Access Compliance Report

Public Rights-of-Way

(Curb Ramps)

Intersection ID: 48581	Main Street: WATERLILY_LN	Cross Street: RUMPLE_RD	Location: NW
ADA ID: 5A6C5DE69FF9	Ramp Type: BlendTrans1	Initial Pass/Fail: Fail	Overall Compliance: No
Codes/Mitigation Info/Possible Solution		Field Measurements/Component Compliance	
Severity Score: 8.75

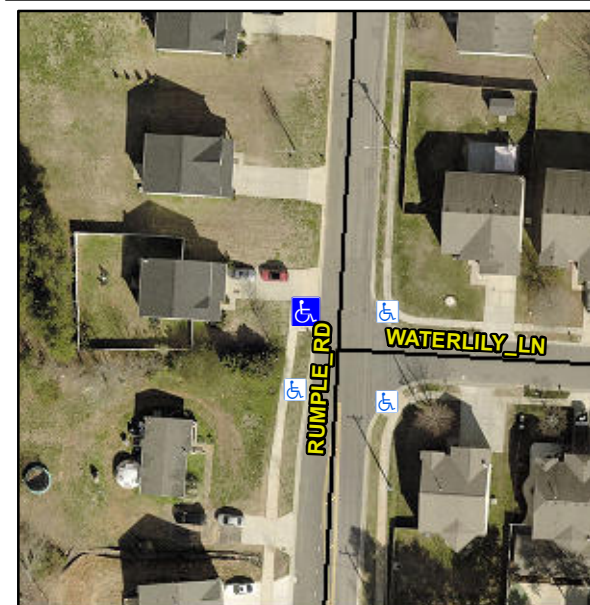
Remove & Replace Curb Ramp With Two New Directional Ramps or Equivalent.

Not Found, R304.5.1
